Add info concerning the review of the ECCS evaluation model.....

PLANT NAME: **Kewaunee**

Subject: Docket 50-305  
Operating License DPR-43  
ECCS Evaluation Model Parameters

FIGURE 1

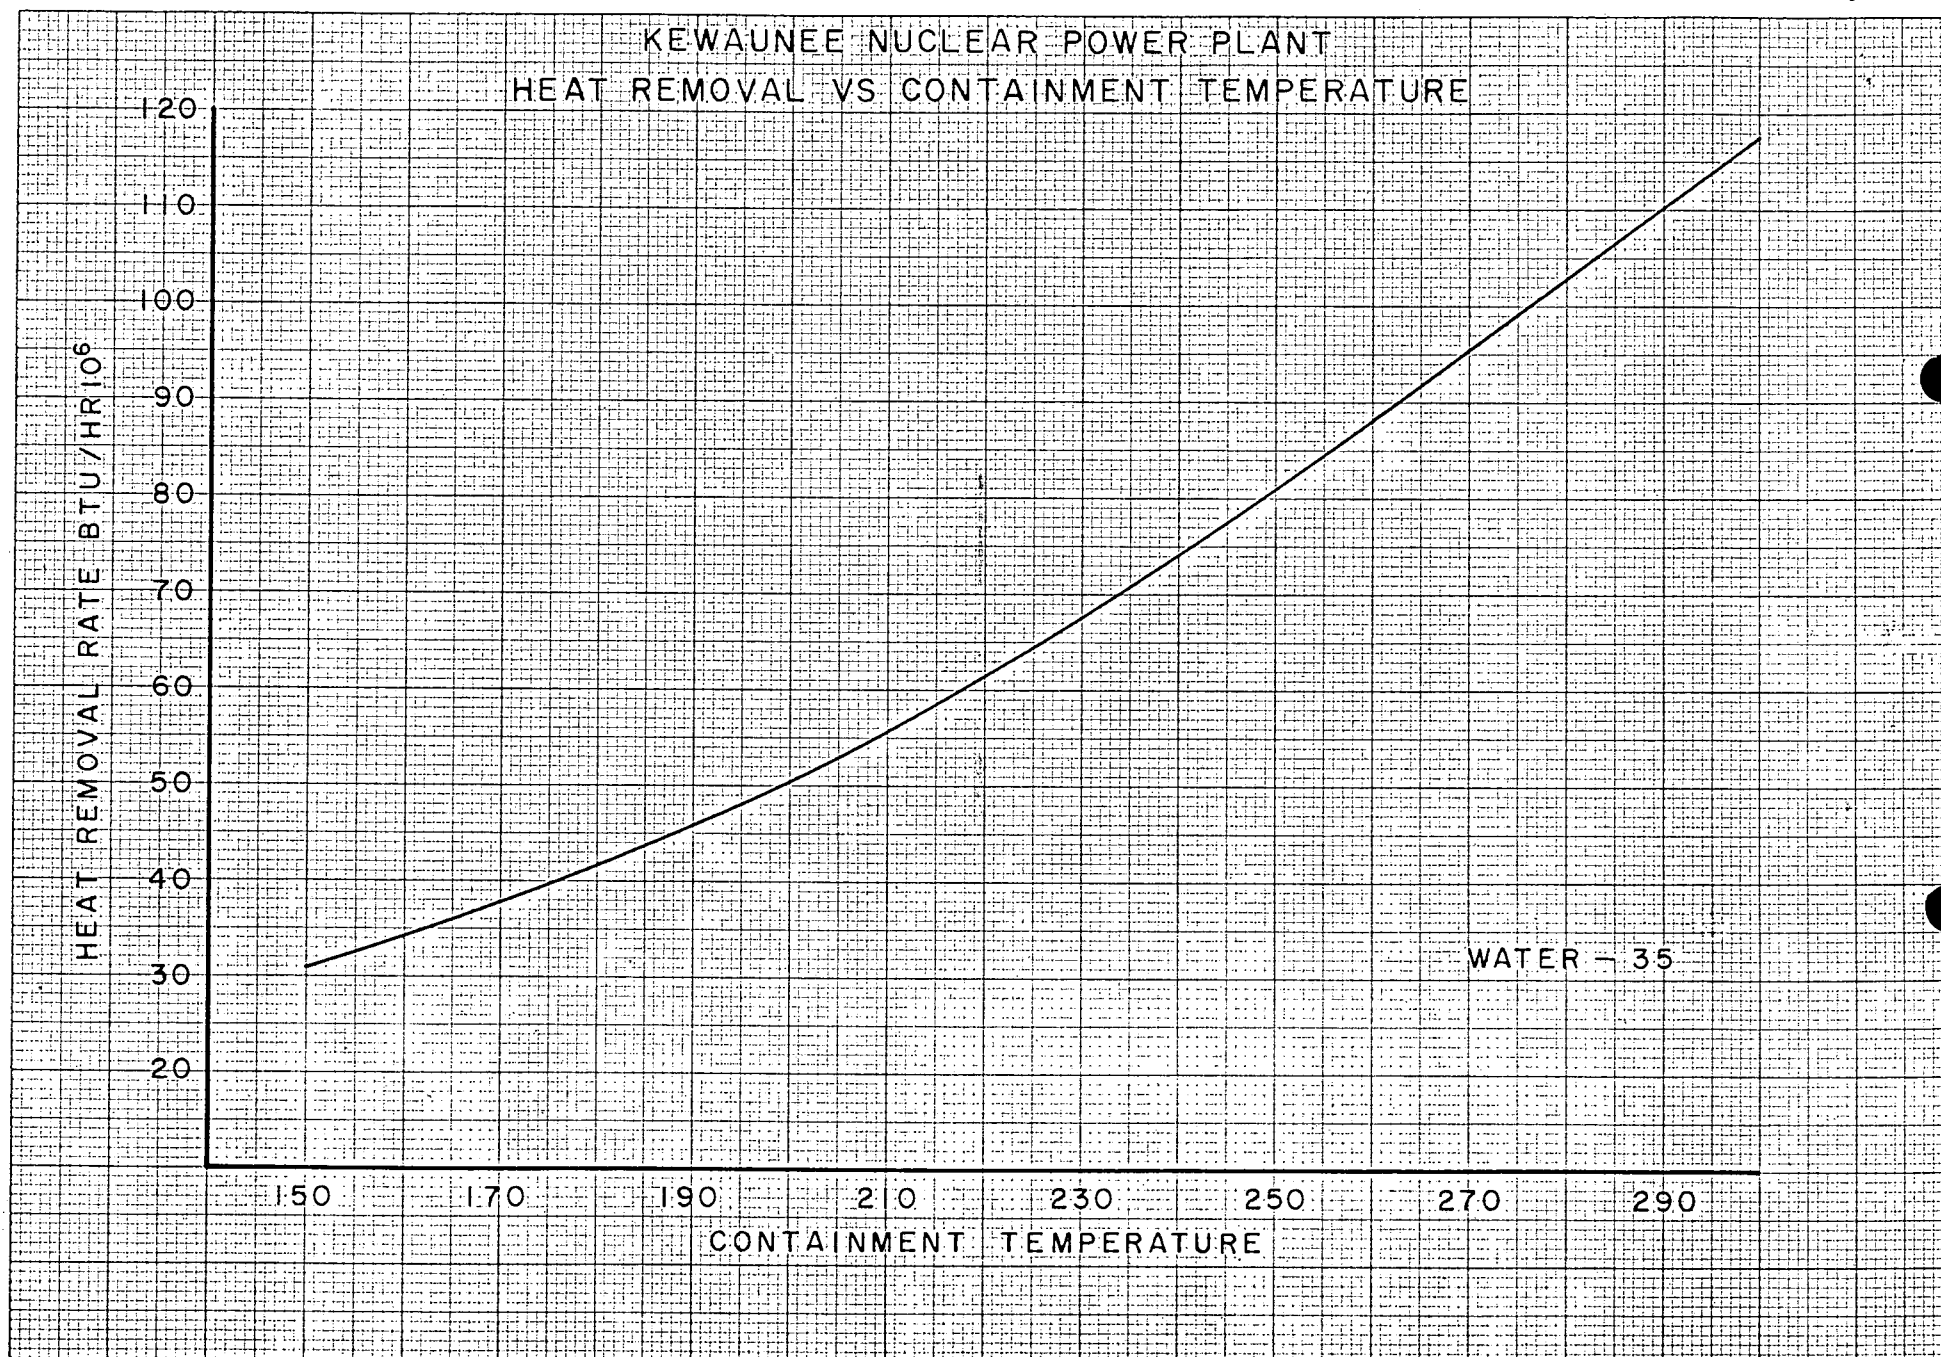
For the most severe break provide the following information:

- a) Fan-cooler heat removal rate as a function of containment atmosphere temperature. Show that minimum operational values of service water temperature have been used in determining the fan-cooler heat removal rate.
- b) Mass and energy release rates to the containment as a function of time during the blowdown, refill, and reflooding periods of the accident. Include any spilled ECCS water.

- a) Figure 1, attached provides the fan cooler heat removal rate as a function of containment atmosphere temperature. The variation between the 35°F cooling water temperature and analysis value of 32°F temperature is negligible.
- b) Table 2, attached, provides the blowdown mass and energy releases as a function of time for the most severe break. Table 3, attached, provides the reflood mass and energy releases as a function of time. Table 4, attached, provides the broken loop accumulator flow to the containment as a function time.
